TRC AGENDA

CITY OF DELAND
THURSDAY NOVEMBER 17, 2022 AT 1:30 P.M.
CITY OF DELAND TRC MEETING ROOM
DELAND, FLORIDA

Issues for record SP22-131
Job Address: 0 S Woodland BLVD,
Job Description: drive thru coffee shop

City of DeLand
TRC
SP22-131
NOVEMBER 17, 2022

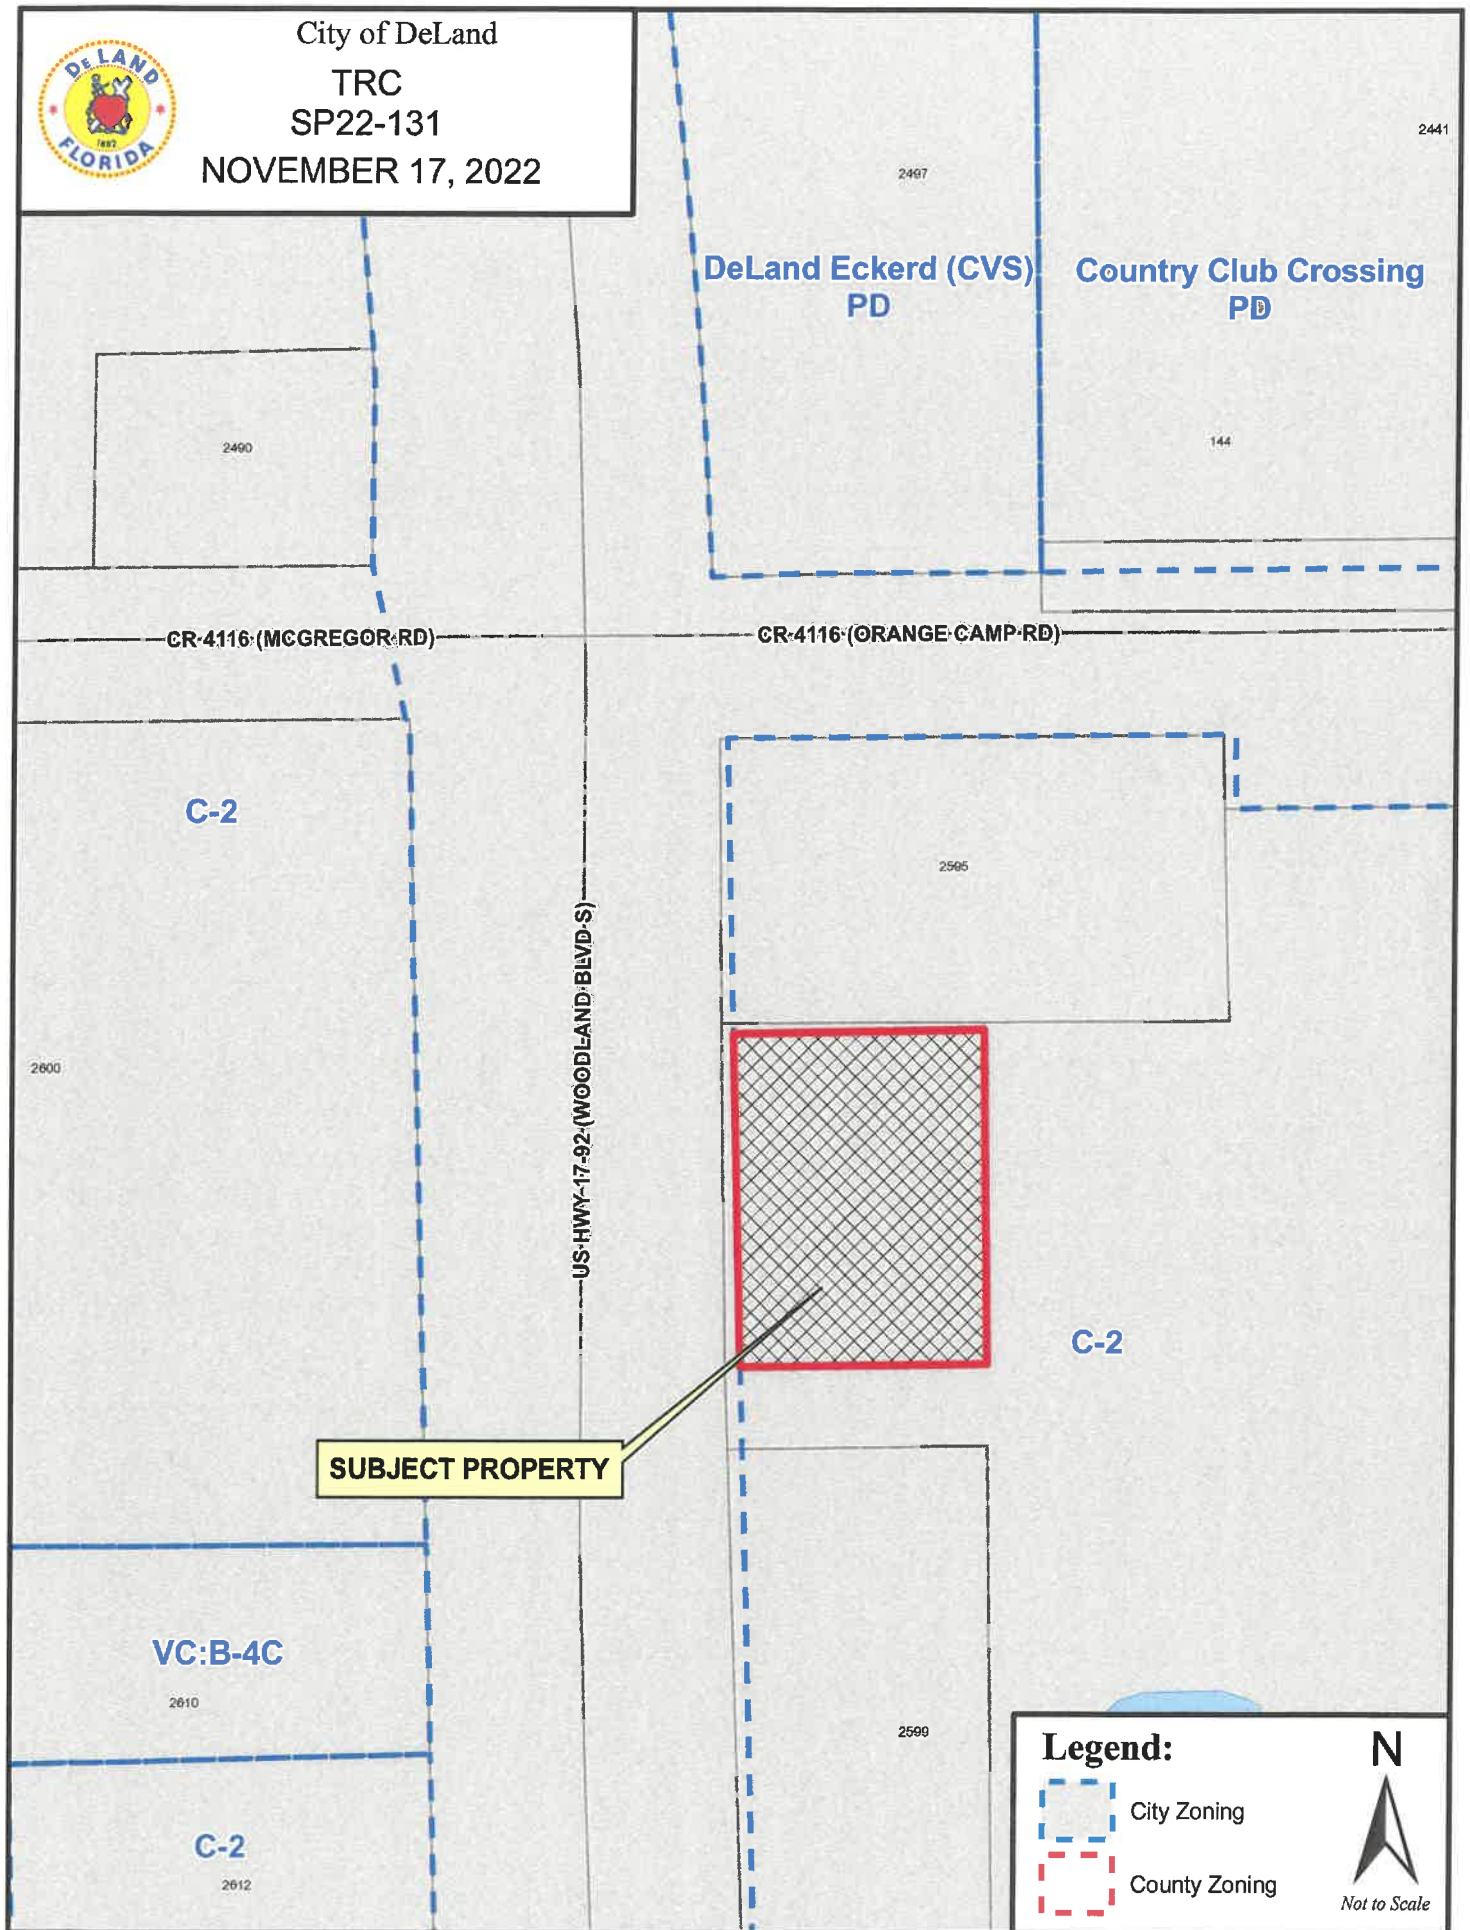
Discipline	Status	Details	Attached To	Created By	Last Updated By	Modifications Required
Forestry	Not Accepted	Work within dripline of historic tree/trees The removal of three parking spaces at the north end of the project area is within the dripline of two historic trees. Please coordinate this work with an arborist with experience in preserving historic trees. We recommend that your private arborist be present during demolition work in this area so that any potential root issues can be properly addressed. Last comment from reviewer: The note regarding removing 550 sf of asphalt is still on this sheet. Last response: Site has been redesigned to move the parking outside the dripline, and an arborist has been retained.	C-012	Mariellen Calabro	Mariellen Calabro	Yes

City of DeLand
TRC
SP22-200
NOVEMBER 17, 2022

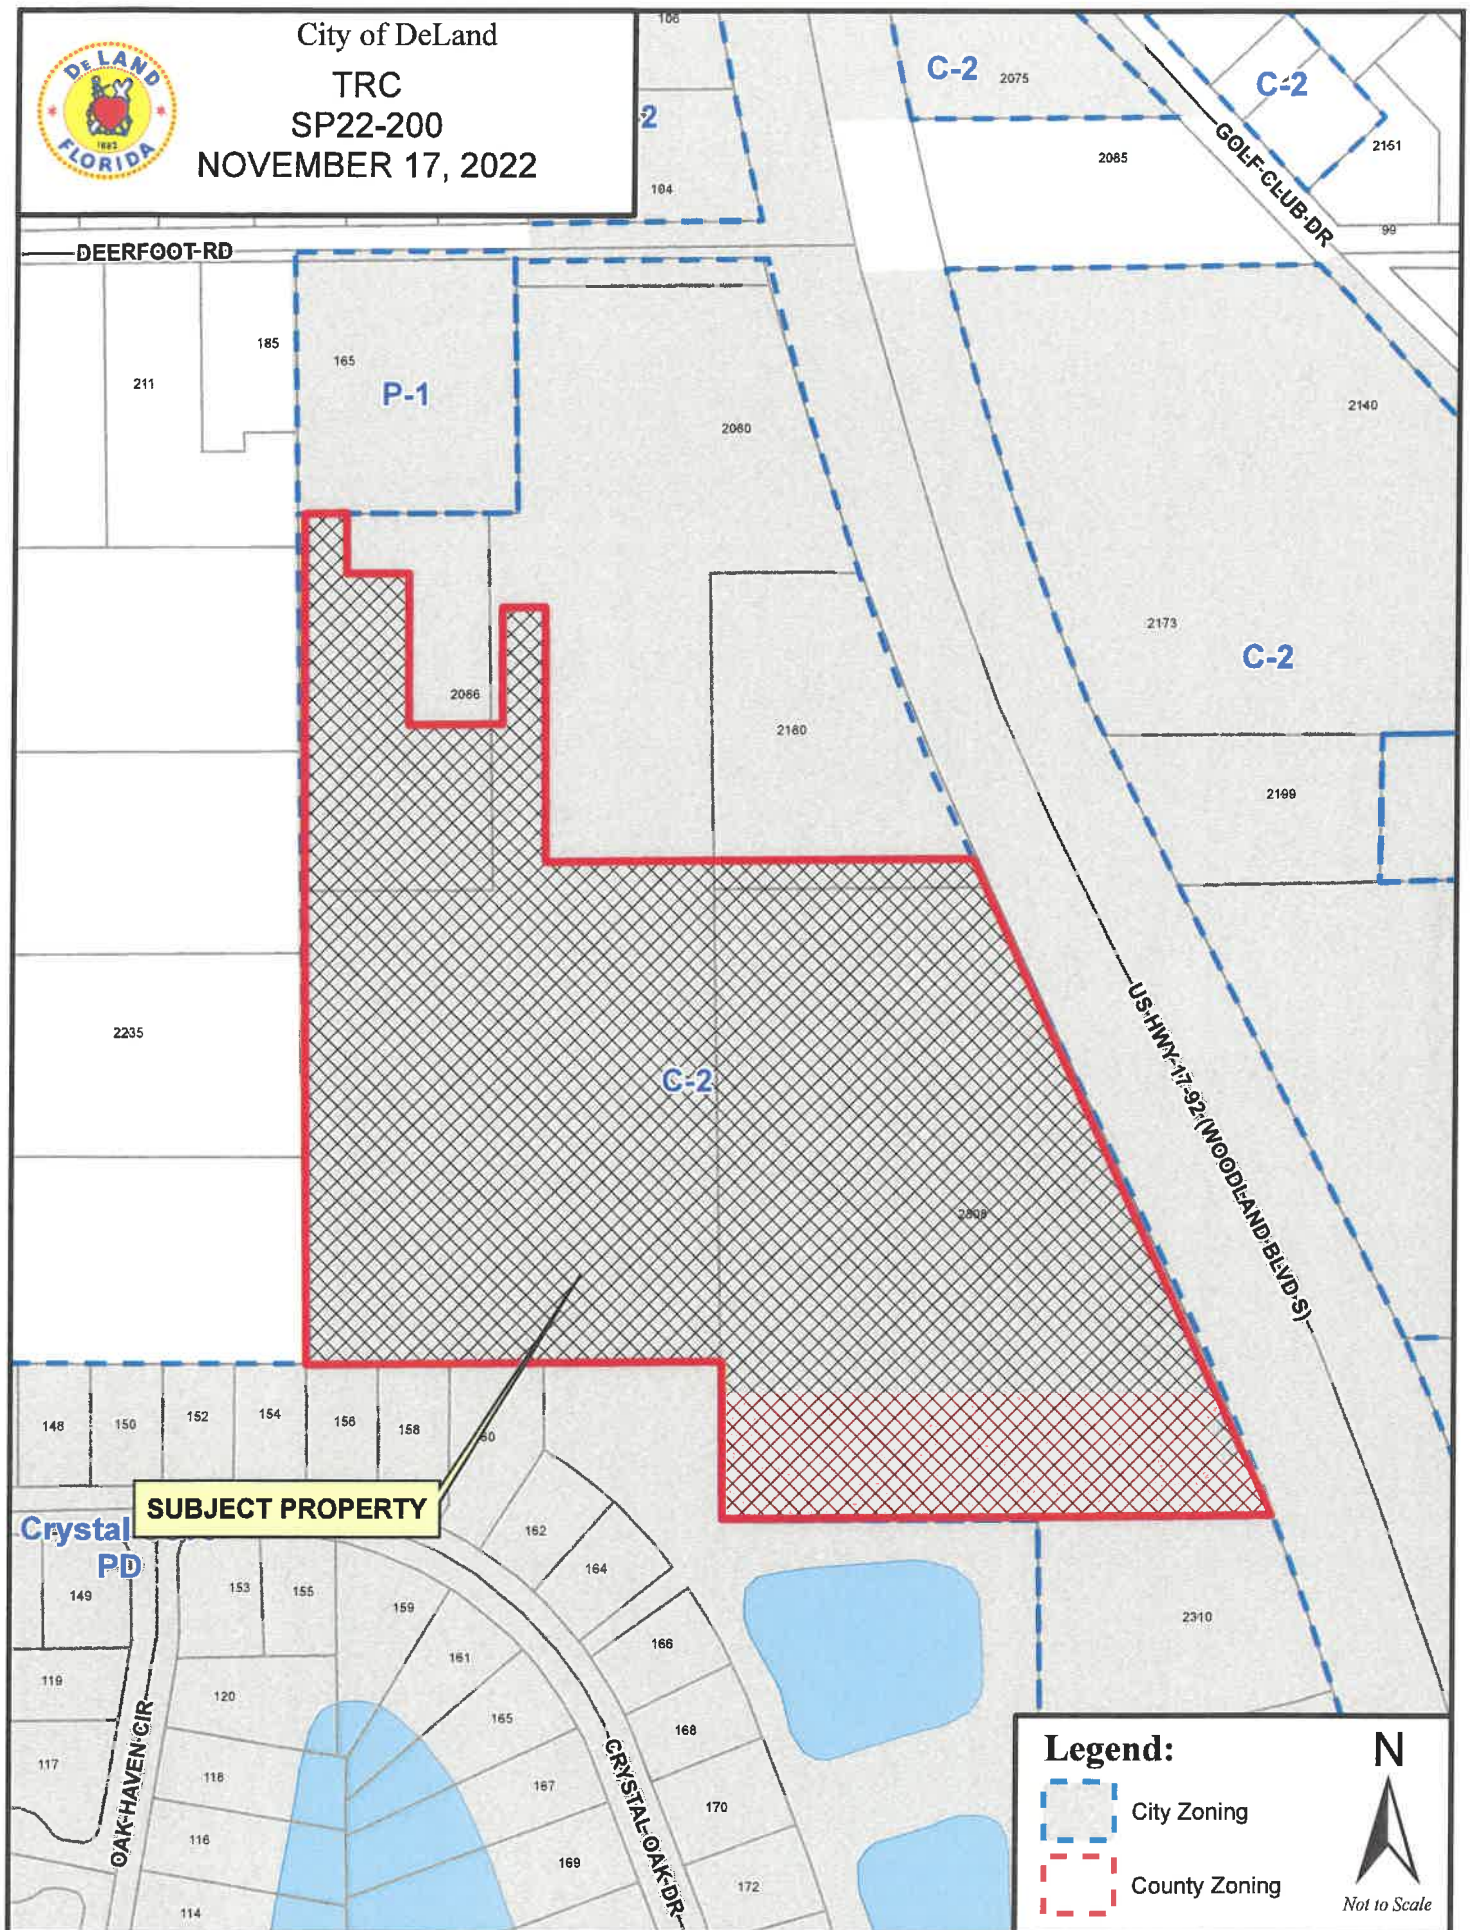
Discipline	Status	Details	Attached To	Created By	Last Updated By	Modifications Required
Legend Box						
Engineering	Draft	1. Legend box has FEMA Floodplain Boundary line. Are there 100-year flood impacts on this project? If none, please remove this from legend box on all sheets.	C3.0	Tuan Huynh	Tuan Huynh	Yes
Soil Types						
Engineering	Draft	1. Soil Types shown does not match drainage report soil map.	C2.0	Tuan Huynh	Tuan Huynh	Yes
Drainage Calculations						
Engineering	Draft	1. Narrative Table 1: Groundwater elevations, boring P-7 seasonal high groundwater table should be 11.7 feet and not 12.0 feet.

2. SCS Soil Map: please include soil description pages for Tavares Fine Sand and its hydrological soil group (Type 'A') along with the soil map ID.

3. Pre-development Curve Number Worksheet: Please change sheet heading, it shows Post-Development.				
		4. Pre-development Drainage Calculations: Please include stage/storage volume spreadsheet for the existing depressional area to support ICPR input.

5. Pre-development ICPR Volume Inflow: Boxed results do not match Table 8 Volume Analysis Summary.				
		6. Post-development Curve Number Worksheet: Basin Post-C1 assumes Woods coverage with curve number (CN = 25) for the proposed dry pond area. Should (CN = 39) for open space, grass coverage > 75% instead, since pond will be sodded and existing trees be removed within the pond limits? Please clarify or revise ICPR input.

7. Post ICPR Input: Node Pond input elevations do not increase incrementally similar to the depressional area input. Please revise for consistency.

8. Post ICPR Input: Node Pond area input at elevation 22.0 does not match Stage/Storage spreadsheet. Other area input differs slightly from the spreadsheet computed areas.

9. Post ICPR Input: Drop Structure (CS-1) link shows 18" outfall pipe upstream invert of 19.50, but Plans Sheet C7.0 detail shows invert 19.0. Also, pipe length is 86 LF in ICPR but is 39 LF on Plan Sheet C5.2.

10. Post ICPR Input: Drop Structure (CS-1) link show 1.5 feet wide rectangular weir slot at invert 22.10. But Plan Sheet C7.0 control structure details do not show the weir slot.

Discipline	Status	Details	Attached To	Created By	Last Updated By	Modifications Required
Gravity Wall						
Engineering	Draft	1. Provide linear-feet (LF) of each gravity wall for each wall segment and do likewise for sheet C4.2. 2. Can the gravity wall be constructed without encroaching on the proposed cell tower property line as shown on the plans?	C4.1	Tuan Huynh	Tuan Huynh	Yes
Grade Cross-Section Callout						
Engineering	Draft	1. Grade Sections callout sheet C5.10 for the detail location, but details are on sheet C8.0. Please revise.	C5.2	Tuan Huynh	Tuan Huynh	Yes
General Comments						
Engineering	Draft	1. This development is adjacent to Woodland Blvd.; therefore, FDOT Permit is required. 2. Please provide a copy of SJRWMD / FDEP permit or letter modification upon approval. This is required prior to scheduling a pre-construction meeting.		Tuan Huynh	Tuan Huynh	Yes
Retention Pond						
Engineering	Draft	1. Label Pond as "Dry Retention Pond". 2. Pond Bottom is 19.0 feet on sheets C5.2 and C7.0, but drainage report used pond bottom at 18.0 feet in report narrative, stage/storage spreadsheet, and ICPR Post input. Please revise plans or drainage report.	C5.2	Tuan Huynh	Tuan Huynh	Yes

Hydrants						
Fire	Draft	Additional Fire Hydrant needed. Travel distance between hydrants and furthest location of need cannot exceed 500 ft. Consider indicated areas for hydrants of something similar.	C6.0	Jamie Lunsford	Jamie Lunsford	Yes
ID Historic Trees						
Forestry	Draft	Label historic trees as historic and show 1.5 times the dripline on the plan.	L0.51	Mariellen Calabro	Mariellen Calabro	Yes
Water Oaks						
Forestry	Draft	Fix spelling of water	L0.56	Mariellen Calabro	Mariellen Calabro	Yes
Water Tupelo						
Forestry	Draft	Are you sure about this species ID. This is an unusual location for this species.	L0.51	Mariellen Calabro	Mariellen Calabro	Yes

Discipline	Status	Details	Attached To	Created By	Last Updated By	Modifications Required
Specimen and Historic Tree Impacts						
Forestry	Draft	This project will result in impacts to specimen and historic trees. Please provide excel spreadsheet showing trees to be removed and preserved. Historic, specimen, and protected trees need to be identified in the spreadsheet. Your worksheet indicates that 2,432" DBH of tree replacement will need to be provided on your landscape plan. I cannot verify this without more information.	L0.51	Mariellen Calabro	Mariellen Calabro	Yes
Tree Calculations						
Forestry	Draft	Please provide excel spreadsheet showing trees to be removed and preserved. Historic, specimen, and protected trees need to be identified in the spreadsheet. Your worksheet indicates that 2,432" DBH of tree replacement will need to be provided on your landscape plan. I cannot verify this without more information. You are also missing several trees on the plan.	L0.57	Mariellen Calabro	Mariellen Calabro	Yes

Total Impacts to be Mitigated						
Forestry	Draft	Your landscape plan currently adds 211" DBH. This leaves a 2,221" DBH deficiency. At \$75 per inch not planted, this would require a contribution of \$166,575 into the Tree Replacement Reserve Account if additional trees are not added to your landscape plan.	L0.57	Mariellen Calabro	Mariellen Calabro	Yes
Note A. 5.						
Forestry	Draft	Existing tree locations and sizes are required to be based on an actual, current survey, not an estimate.	L0.58	Mariellen Calabro	Mariellen Calabro	Yes
Tree Barricade Detail						
Forestry	Draft	Replace with City standard tree barricade detail.	L0.58	Mariellen Calabro	Mariellen Calabro	Yes
Plant Schedule						
Forestry	Draft	Add minimum root ball and spread to specifications for trees.	L1.00	Mariellen Calabro	Mariellen Calabro	Yes
Notes A. 9. and 10.						
Forestry	Draft	Any construction within the dripline needs to be identified and approved prior to site plan approval. Tree well locations and design need to be reviewed and approved prior to construction. A general note is not sufficient.	L0.58	Mariellen Calabro	Mariellen Calabro	Yes

Discipline	Status	Details	Attached To	Created By	Last Updated By	Modifications Required
The second note E. 9.						
Forestry	Draft	We recommend removing this section as pruning for root loss is generally not needed. If you keep it, fix grammar errors in first line and remove notes a. and b.	L0.58	Mariellen Calabro	Mariellen Calabro	Yes
Note 19						
Forestry	Draft	Replace "plant material" with "ground cover" in note. Tree counts need to be accurate.	L1.00	Mariellen Calabro	Mariellen Calabro	Yes
Note 25						
Forestry	Draft	Remove note 25. Florida Grades and Standards do not apply to existing trees.	L1.00	Mariellen Calabro	Mariellen Calabro	Yes
Note 31						
Forestry	Draft	Remove reference to Hillsboro County.	L1.00	Mariellen Calabro	Mariellen Calabro	Yes
Plant Schedule						
Forestry	Draft	Your current plan would provide 211 inches of replacement. This is not sufficient for the impacts associated with this project.	L1.00	Mariellen Calabro	Mariellen Calabro	Yes

Existing Trees						
Forestry	Draft	Add species and DBH to existing trees.	L1.01	Mariellen Calabro	Mariellen Calabro	Yes
Existing Trees						
Forestry	Draft	Add species and DBH to existing trees.	L1.02	Mariellen Calabro	Mariellen Calabro	Yes
Swales, fences, and shrubs						
Forestry	Draft	Several trees shown and preserved have fences and swales right next to them and shrubs planted on top of them. Please revise your plan to preserve these trees. This may require removing some parking spaces, moving the fencing and adjusting the location of shrubs.	L1.01	Mariellen Calabro	Mariellen Calabro	Yes
Possible historic trees						
Forestry	Draft	The highlighted trees are specimen and may be historic. The plan needs to be adjusted to save these trees from unacceptable impacts to their critical root zones.	L1.01	Mariellen Calabro	Mariellen Calabro	Yes
Proposed 6' high masonry wall and shrubs						
Forestry	Draft	The proposed wall and shrubs appear to be within the critical root zone of existing trees.	L1.02	Mariellen Calabro	Mariellen Calabro	Yes

Discipline	Status	Details	Attached To	Created By	Last Updated By	Modifications Required
Tree Replacement Worksheet						
Forestry	Draft	Please provide excel spreadsheet showing trees to be removed and preserved. Historic, specimen, and protected trees need to be identified in the spreadsheet. Your worksheet indicates that 2,432" DBH of tree replacement will need to be provided on your landscape plan. I cannot verify this without more information. Your landscape plan currently adds 211" DBH. This leaves a 2,221" DBH deficiency. At \$75 per inch not planted, this would require a contribution of \$166,575 into the Tree Replacement Reserve Account if additional trees are not added to your landscape plan.	TreeWorksheet.pdf	Mariellen Calabro	Mariellen Calabro	Yes
Historic and Specimen Tree Impacts						
Forestry	Draft	Some historic and specimen trees do not appear to have sufficient protection. Trees 290079 and 2989 appear to be too close to proposed parking areas to protect their critical root zones.	L0.51	Mariellen Calabro	Mariellen Calabro	Yes

Historic Tree Impacts						
Forestry	Draft	All proposed historic tree removals need to be reviewed by the Tree Advisory Committee and approved by the City Commission. This process will add at least two months to your project schedule. We recommend preserving as many historic trees as possible.	L0.51	Mariellen Calabro	Mariellen Calabro	Yes
23" and 24" DBH Live Oaks						
Forestry	Draft	For trees that are close to historic size, you might want to schedule a field visit with Chris Jackson (jacksonc@deland.org) to make sure that they are not historic to avoid possible project delays.	L0.51	Mariellen Calabro	Mariellen Calabro	Yes
Trees 3109, 3110, 3111, 3112, 3113, 3115, 3116, and 3117						
Forestry	Draft	These trees are not shown on your tree list and do not have a DBH on plan. There may be more. Please review your data and update.	L0.51	Mariellen Calabro	Mariellen Calabro	Yes
Tree Calculations

Forestry	Draft	Please provide excel spreadsheet showing trees to be removed and preserved. Historic, specimen, and protected trees need to be identified in the spreadsheet. Your worksheet indicates that 2,432" DBH of tree replacement will need to be provided on your landscape plan. I cannot verify this without more information. You are also missing several trees on the plan. Your landscape plan currently adds 211" DBH. This leaves a 2,221" DBH deficiency. At \$75 per inch not planted, this would require a contribution of \$166,575 into the Tree Replacement Reserve Account if additional trees are not added to your landscape plan.	L0.56	Mariellen Calabro	Mariellen Calabro	Yes

Discipline	Status	Details	Attached To	Created By	Last Updated By	Modifications Required
Trees and Vegetation Notes 3 and 4						
Forestry	Draft	A separate tree removal permit is not required for this project. All tree-related impacts need to be addressed in the site plan documents. Any additional impacts that are not addressed in this plan would require a landscape plan modification.	C1.0	Mariellen Calabro	Mariellen Calabro	Yes
Tree Protection Area Worksheet						
Forestry	Draft	Tree Protection Area Worksheet has not been completed.	TreeWorksheet.pdf	Mariellen Calabro	Mariellen Calabro	Yes
Total Inches to be Mitigated						
Forestry	Draft	Round 2,431.5 to 2,432.	L0.50	Mariellen Calabro	Mariellen Calabro	Yes
Vehicle Use Area						
Planning	Draft	The minimum separation between vehicle use areas and the property line is required to be 10-ft. The plan shows two locations that encroach into the 10-ft and appear to provide space for motorists to be able to back vehicles out of parking spaces. If the applicant is able to verify that these encroachment locations do not impact the landscape buffer requirements, staff may adjust or waive this requirement. Please state your request to be voted on in TRC.	C4.0	Melissa Winsett	Deborah Glick	Yes

Site Data						
Planning	Draft	1. Please include the Future Land Use: Highway Commercial. 2. Correct the Required Landscape Buffers for the South and West to reflect 25-ft in lieu of 20-ft. 3. Please state that the site is not in a historic preservation area.	C4.0	Melissa Winsett	Deborah Glick	Yes
Miscellaneous						
Planning	Draft	1. All revisions must be depicted as clouded. 2. A photometric plan was not provided. Please submit in the revised plans. 3. Advisory: Please be sure to update the date of revised plans and update the Revisions section. This was not done in the Special Exception site plan review, which caused some confusion. 4. Please rename the plan (currently named "Coggin Hyundai Parking Expansion") as "Coggin Hyundai Inventory Storage Lot" or a similar name to clearly document that the project is not a parking lot or expanded parking lot for sales and automobile shopper access.	C4.0	Melissa Winsett	Deborah Glick	Yes

Discipline	Status	Details	Attached To	Created By	Last Updated By	Modifications Required
Landscape Buffer Information						
Landscape Buffers: Please provide the following information for each buffer (table format is preferred), Note: The plan provides some of this information, but not the total needed for clarification: 1. Buffer Type & Location 2. Required Buffer Width & Proposed Buffer Width 3. Length of each buffer & calculations per 100-Linear ft. 4. Required Canopy dbh & Height & Proposed Canopy dbh & Height 5. Required number of canopy & Proposed number of canopy 6. Required number of understory & Proposed number of understory 7. Required number of shrubs & Proposed number of shrubs						
Planning	Draft		L1.00	Melissa Winsett	Melissa Winsett	Yes
Note #10						
Utilities	Draft	Wire size by city spec is 10 gauge.	C1.1	Jim Ailes	Jim Ailes	Yes
Irrigation Source						
Utilities	Draft	What source of water is used for irrigation.	L2.01	Jim Ailes	Jim Ailes	Yes

Testing						
Utilities	Draft	City requires that lines be swabbed with a swab 2" larger than the line installed prior to pressure testing and chlorination, Note #4.	C1.1	Jim Ailes	Jim Ailes	Yes
Hydrant						
Utilities	Draft	All hydrants will be private.	C6.0	Jim Ailes	Jim Ailes	Yes
